Access Compliance Report

Public Rights-of-Way

Intersection ID: 10021121	Main Street: BEVINGTON_PL	Cross Street: MITCHELL_HOLLOW_RD	Location: NE
ADA ID: 4E944A624706	Ramp Type: PerpDiag	Initial Pass/Fail: Fail	Overall Compliance: No
Severity Score: 21.25			
Codes/Mitigation Info/Possible Solution		Field Measurements/Component Compliance

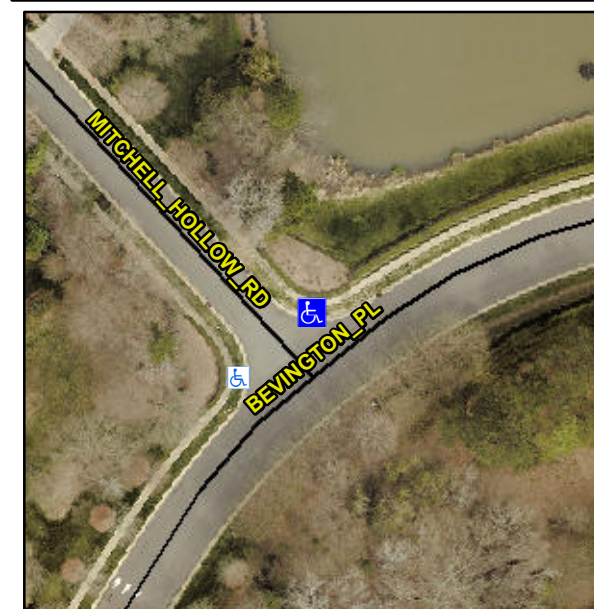
Not Found, R304.5.1, R304.2.2

Compliance	Description	Data	Compliance	Description	Data
N/A	Ramp Length (in)	68.0	No	Ramp Slope (%)	8.4
No	Ramp Width (in)	47.0	Yes	Ramp XSlope (%)	1.9
N/A	Flare Type LT	N/A	N/A	Flare Type RT	N/A
N/A	Flare Slope LT (%)	N/A	N/A	Flare Slope RT (%)	N/A
N/A	Flare Traversable LT?	N/A	N/A	Flare Traversable RT?	N/A
N/A	Landing Length (in)	N/A	N/A	DWS Provided?	N/A
N/A	Landing Width (in)	N/A	N/A	DWS Contrast?	N/A
N/A	Landing Slope (%)	N/A	N/A	DWS Length (in)	N/A
N/A	Landing X Slope (%)	N/A	N/A	DWS Full Width?	N/A
N/A	Landing Curb? (Y/N)	N/A	N/A	DWS Offset (in)	N/A
N/A	Shared Landing?	N/A			
N/A	Gutter Ponding?	N/A	N/A	Gutter Slope (%)	N/A
N/A	Gutter Lip Ht (in)	N/A	N/A	Gutter X Slope (%)	N/A
N/A	Painted X Walk1?	No	N/A	Painted X Walk2?	No
	X Walk 1 Direction	To SW		X Walk 2 Direction	To SE
N/A	X Walk 1 Width (in)	N/A	N/A	X Walk 2 Width (in)	N/A
	X Walk 1 Slope (%)	3.0		X Walk 2 Slope (%)	1.3
	X Walk 1 X Slope (%)	2.8		X Walk 2 X Slope (%)	2.3

Remove & Replace Curb Ramp With Two New Directional Ramps or Equivalent.
